DEVELOPMENT REVIEW COMMITTEE (DRC) COMMENT REPORT

MEETING DATE:	June 25, 2019
APPLICANT:	Bank of America Corporate Real Estate Assessment
PROJECT NAME:	Shoppes at Rio Vista
CASE NUMBER:	R19040
REQUEST:	Site Plan Level II Review: 17,498 Square Feet of Retail Use, 5,540 Square Feet of Financial Institutional Use and 2,205 Square Feet of Restaurant Use
LOCATION:	901 SE 17th Street
ZONING:	Boulevard Business (B-1)
LAND USE:	Commercial
CASE PLANNER:	Adam Schnell

Exhibit 1. Landscaped Pergola/ Trellis (The Fresh Market, 424 N Federal Hwy, Fort Lauderdale, FL 33301)

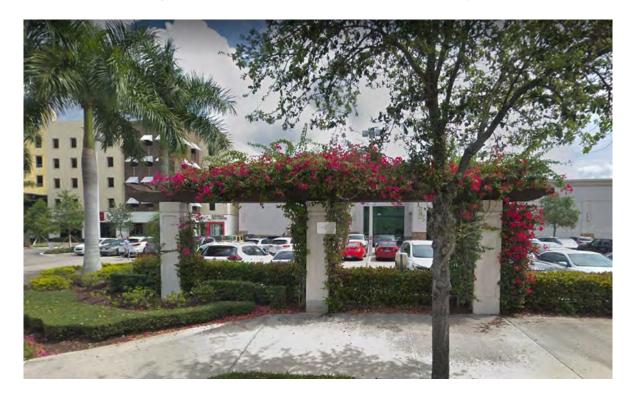
- f. Consider the integration of larger seating areas and include benches and plaza space for patrons.
- g. To support a smoother transition from nonresidential to residential uses along SE 16th Court, consider the integration of landscaped pergolas and trellises. Reference **Exhibit 1**.
